From: Habib, Donald
Sent: Wednesday, June 6, 2018 7:18 AM
To: Vogle PEmails
Subject: FW: LAR-17-037 site audit June 7-8 2018 Draft A.pptx
Attachments: LAR-17-037 site audit June 7-8 2018 Draft A.pptx

From: Redd, Jason P. [mailto:JPREDD@southernco.com]
Sent: Wednesday, June 06, 2018 12:20 AM
To: Habib, Donald <Donald.Habib@nrc.gov>; Hoellman, Jordan <Jordan.Hoellman2@nrc.gov>
Cc: Hicks, Thomas E. <X2TEHICK@southernco.com>; Haggerty, Neil <X2NHAGGE@SOUTHERNCO.COM>; Pugh, Amanda Louise <ALPUGH@southernco.com>; Clough, Ken <X2KCLOUG@SOUTHERNCO.COM>
Subject: [External_Sender] LAR-17-037 site audit June 7-8 2018 Draft A.pptx

Examples of Potential Application of the LAR-17-037-Proposed Tier 2* Change Process to Critical Sections in support of June 7-8, 2018 Onsite NRC Audit

Figure 3H.5-7 – Typical Reinforcement and Connection to the Shield Building

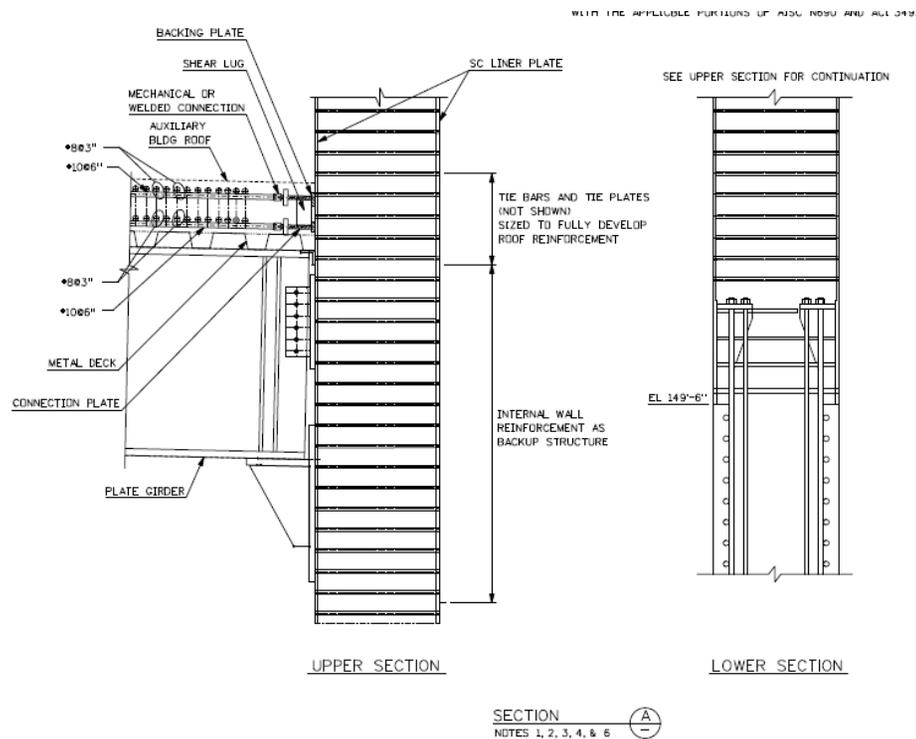
- *[The layout of this segment of the roof is shown in Figure 3H.5-7 as Region "B." The concrete slab is 15 inches thick, plus 4.5-inch deep metal deck ribs. It is composite with 4 feet deep plate girders by using shear connectors. The girder spacing is a range of 13'-0" to 14'-2" center to center. The girder flanges are 26" x 2 1/2" and the web is 43" x 1". The girders span approximately 64 feet in the north south direction and are designed as simply supported. The concrete slab between the girders behaves as a one-way slab and is designed to span between the girders....]**

- Tier 2* text describes girder depth, flange, and web dimensions to the 1/2". For ease of procurement, fabrication, shipment, handling, or installation, the Licensee may prefer to construct this critical section with girders of slightly different dimensions. The Licensee should be able to evaluate use of beams with similar dimensions and properties on an engineering basis, i.e. ACI 349-01 and AISC N690-01 as supplemented by the UFSAR, and if a suitable candidate girder shape is identified, per the B.5.b process and LAR-proposed criteria to determine if such deviation is acceptable without prior NRC approval.

Figure 3.8.3-8 (Sheet 1 of 3) – Structural Modules – Typical Design Details

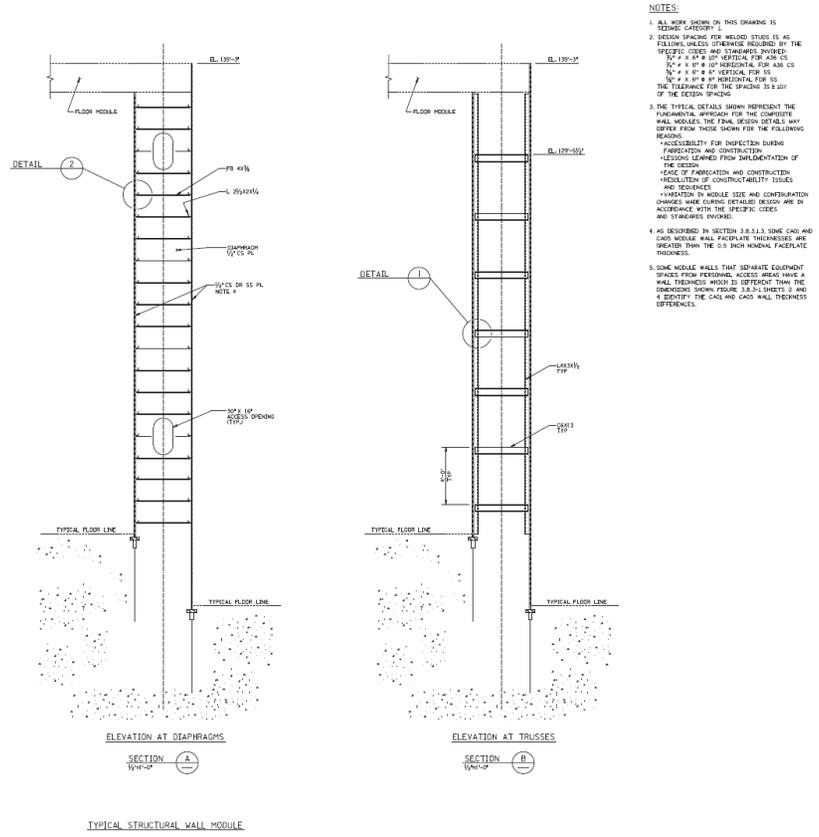
- [... *The modules consist of steel faceplates connected by steel trusses as shown in Figure 3.8.3-2. The primary purpose of the trusses is to stiffen and hold together the faceplates during handling, erection, and concrete placement. The thickness of the steel faceplates is 0.5 inch.....*]*
- Tier 2* text describes structural module faceplates as 0.5” in thickness. Removal of welded attachments (i.e. for handling or temporary supports) or the repair of surface defects may locally reduce the faceplate thickness below of Tier 2* value of 0.5”. Under the proposed process, the Licensee should be able evaluate the proposed change in accordance the design basis code(s), and if technically acceptable, with the B.5.b process and LAR-proposed criteria to determine if such local deviation is acceptable without prior NRC approval.

Figure 3H.5-14 – {Shield Building} Elevation View of Tension Ring and Air Inlets

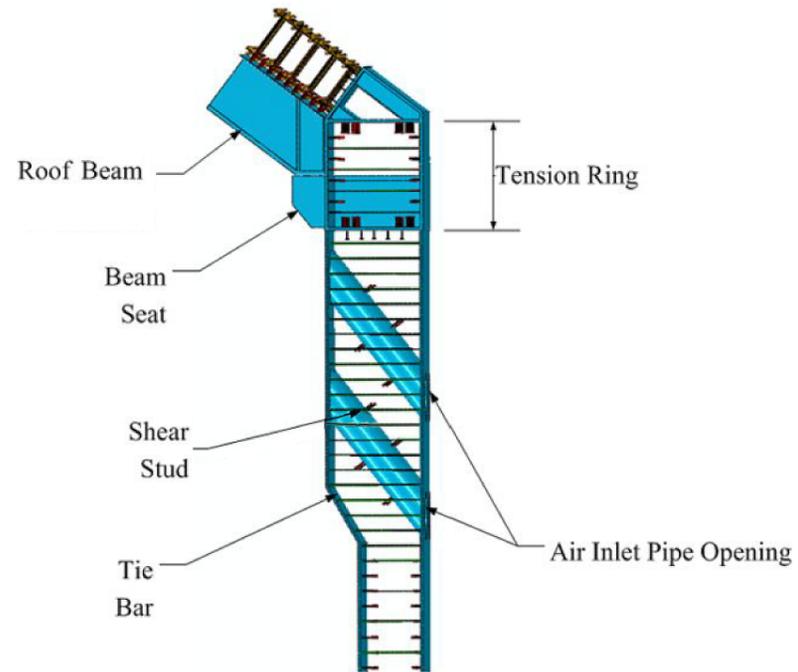
- [... *The air inlet openings are formed using pipe at a downward inclination of 38 degrees from the vertical. The pipe spacing is approximately 2.81 degrees circumferentially with shear studs welded to the outside surface of the pipes. The tie bars are located with three bars between adjacent air inlets at each elevation at maximum design spacing of 8.5 inches vertically.....*]*

- Tier 2* text describes the Shield Building air inlet pipes geometry down to a hundredth of a degree horizontally and single degree vertically. In such a congested rebar location as the air inlet region (see Figures 3H.5-11 and 3H.5-14), it would not be unexpected for either of these field geometric properties to slightly deviate from the Tier 2* values. Likewise, a maximum design spacing of 8.5” vertically is prescribed for the tie bars between air inlets. Again, obstructions may result in local exceedances of that parameter. Under the proposed process, the Licensee should be able evaluate a proposed change in accordance the design basis code(s), and if technically acceptable, with the B.5.b process and LAR-proposed criteria to determine if such local deviation is acceptable without prior NRC approval.

Figure 3H.5-3 – Typical Reinforcement in Wall on Column Line 1

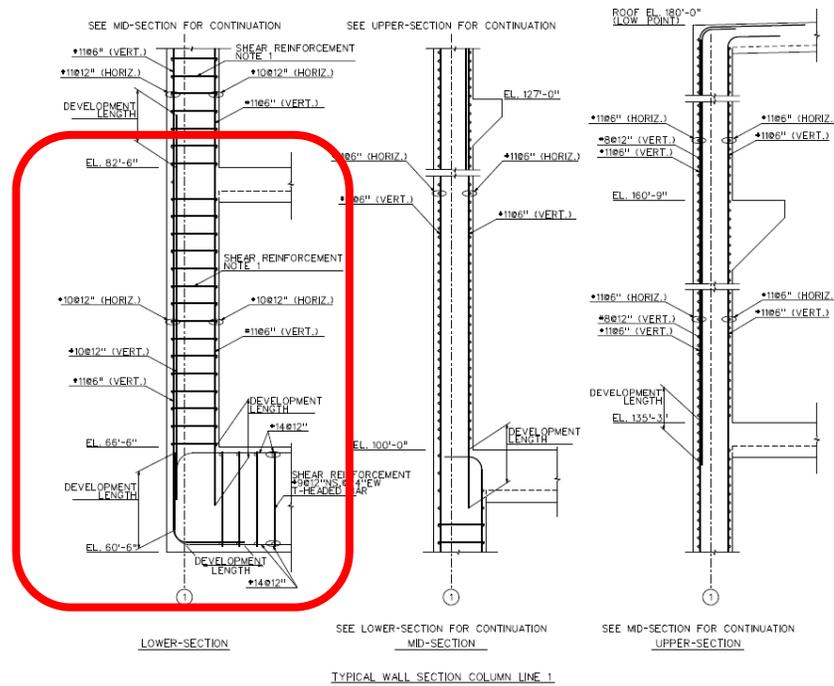
- Table 3H.5-3 defines the minimum provided Column Line 1 wall reinforcement in terms of square inches of steel per foot of wall; these values are designated as Tier 2* material. Corresponding Tier 2* Figure 3H.5-3 visually expresses those minimum provided reinforcement values in terms of rebar sizes and spacing.

- The wall along Column Line 1 is a traditional reinforced concrete wall designed and constructed per ACI 349-01. As shown in Table 3H.5-3, the minimum provided reinforcement exceeds the required reinforcement, typically by a significant amount. While not planned, field construction (even within the UFSAR, ACI 349-01, and Engineer tolerances) may reveal obstructions or interferences which require deviation from the Tier 2* values over a local area – an example being omission of a single vertical rebar at an obstruction, or the substitution of slightly smaller bars in a uniquely congested area which still exceed the required reinforcement but are less than the Tier 2* minimum value. Under the proposed process, the Licensee should be able evaluate a proposed change(s) in accordance the design basis code(s), and if technically acceptable, with the B.5.b process and LAR-proposed criteria to determine if such local deviation is acceptable without prior NRC approval.
